SUBJECT: ISSUANCE OF AMENDMENT NO. 116 TO FACILITY OPERATING LICENSE  
NPF-38 - WATERFORD STEAM ELECTRIC STATION, UNIT 3 (TAC NO. M88853)

WATERFORD STEAM ELECTRIC STATION, UNIT 3

AMENDMENT TO FACILITY OPERATING LICENSE

Amendment No. 116  
License No. NPF-38

FIGURE 5.1-3 SITE BOUNDARY FOR RADIOACTIVE GASEOUS AND LIQUID EFFLUENTS

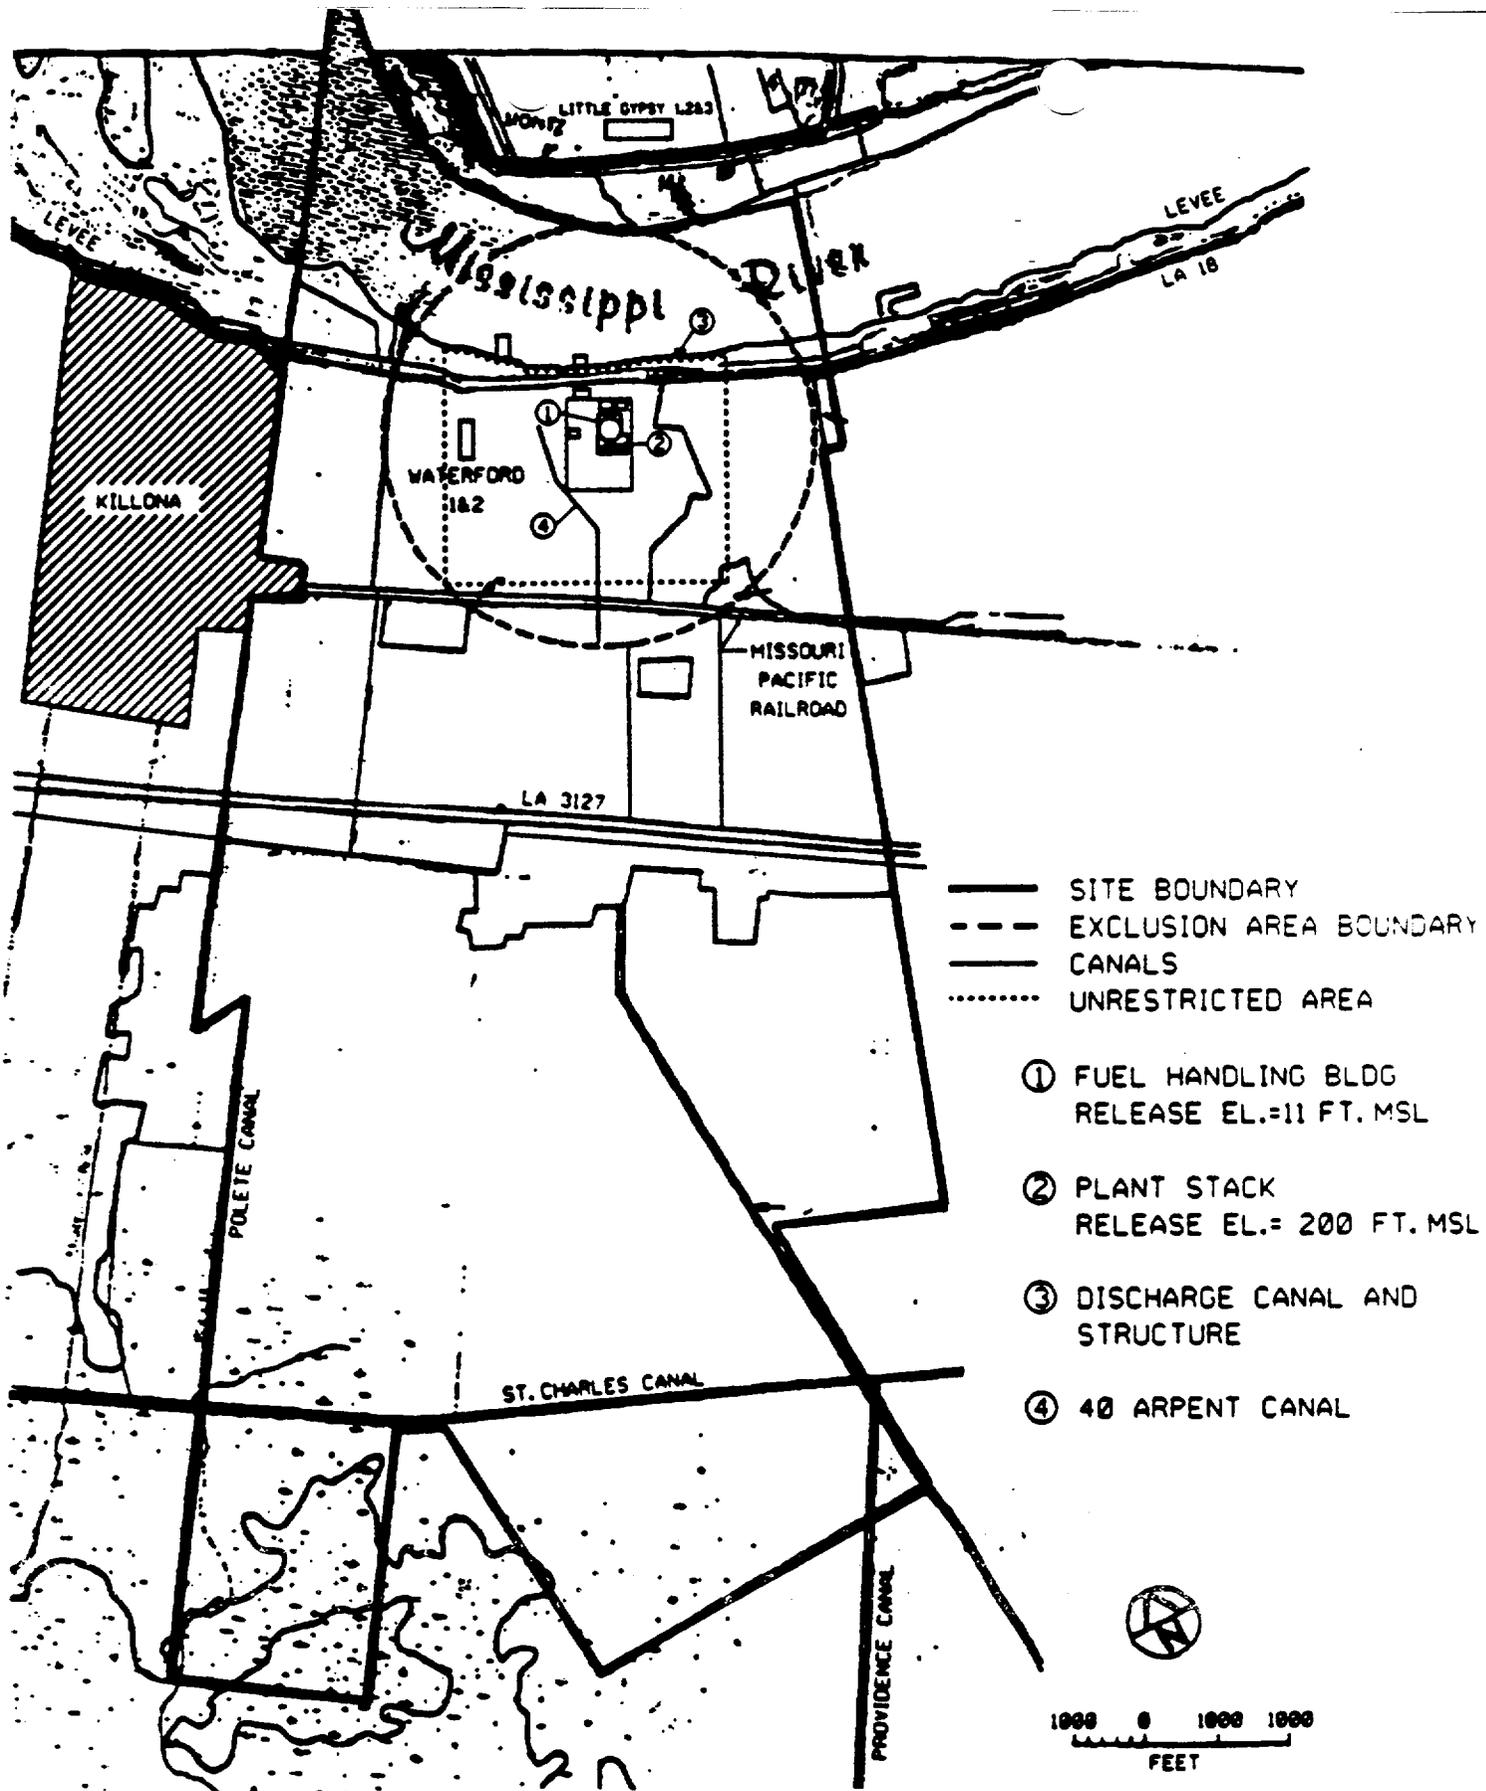
The licensee has proposed to revise this specification to add a paragraph which clarifies the definition of UNRESTRICTED AREA as used in implementing the effluent TS. As a result of the clarification, TS FIGURE 5.1-3 was also revised to move the northern boundary line for the SITE BOUNDARY to the opposite shore of the Mississippi River. The location of the revised SITE BOUNDARY is consistent with the clarification to the definition in that, "...the UNRESTRICTED AREA does not include areas over water bodies." The current Figure depicts the SITE BOUNDARY over water. The proposed revised Figure locates the SITE BOUNDARY in its intended location.

The changes provide clarification to the TS and are consistent with the Standard Technical Specifications and are acceptable.
